BC BUILDING CODE INTERPRETATION COMMITTEE

File No: 18-0063 R1

Interpretation Date:	July 21, 2020 (<i>Revised 2025 08 01</i>)
Building Code Edition:	BC Building Code 2018
Subject:	Location of Smoke Detectors to Close Smoke Dampers
Keywords:	Smoke detectors, motorized smoke dampers
Building Code Reference(s):	3.1.8.11.(3)

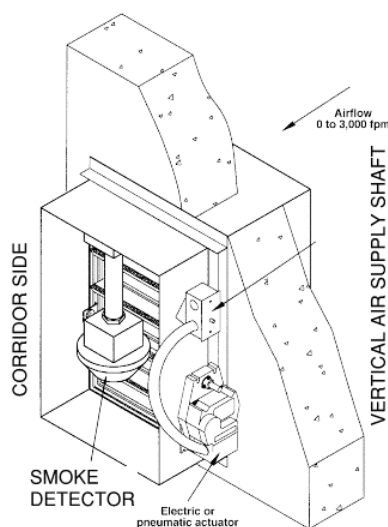
There are smoke/fire dampers that are provided with an integral smoke detector, so those would be another option since they comply with Clause 3.1.8.11.(3)(b) provided that the smoke detector is located on the corridor side of the smoke/fire damper. Note that Sentence 3.1.8.11.(2) allows the combination smoke/fire damper to be offset from the fire separation wall by 610 mm to accommodate the smoke detector on the downstream side of the damper. See illustration below.

See diagrams on Page 4.

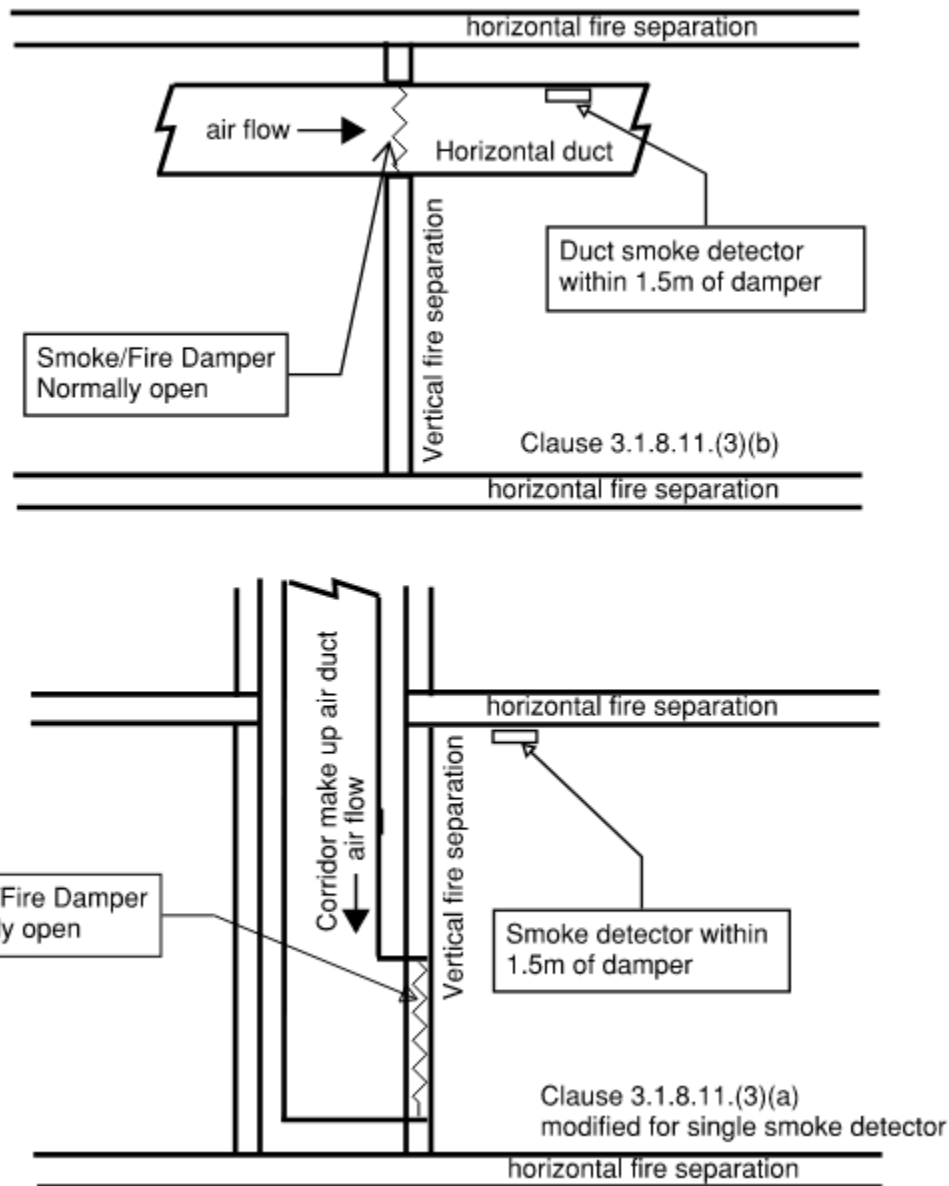
This project utilizes combination motorized smoke/fire dampers that are located at an air transfer louver that provides make up air to a corridor from a vertical duct shaft where the make up air fan is located on the roof.

1. Is the most suitable location to install a smoke detector on the ceiling of the corridor within 1.5m of the smoke/fire damper that, when activated, will close the adjacent smoke/fire damper?
2. Is it acceptable to automatically close all smoke/fire dampers upon activation of any fire alarm initiating device (e.g. sprinkler flow, manual pull, fire detectors)?

Since the intent of Sentence 3.1.8.11.(3) is to prevent the movement of smoke from one fire compartment that contains a fire to another fire compartment, the best location for the smoke detector that closes the smoke/fire damper is on one side of the smoke/fire damper on the ceiling of the corridor within 1.5m of the smoke/fire damper. It is not logical to also install a fire damper on the other side of the smoke/fire damper as suggested by Clause 3.1.8.11.(3)(a) because the only place to install it would be within the vertical duct shaft. A smoke detector within the vertical duct shaft could be activated by a fire on multiple floor levels, so it may close the wrong damper.

It could be interpreted that installing the smoke detector on the ceiling of the corridor meets the intent of Clause 3.1.8.11.(3)(b) since it is located downstream of the smoke damper. The only difference is that it is not located within a duct because there is no duct which is downstream of the smoke damper.

1. Yes (although this is the best location, a code change is required)

The BC Building Code Interpretation Committee has sent a request to NRC to amend the wording of Sentence 3.1.8.11.(3) to allow a single smoke detector on the ceiling of the corridor which is within 1.5m of an air transfer louvre which is connected to a vertical duct shaft.
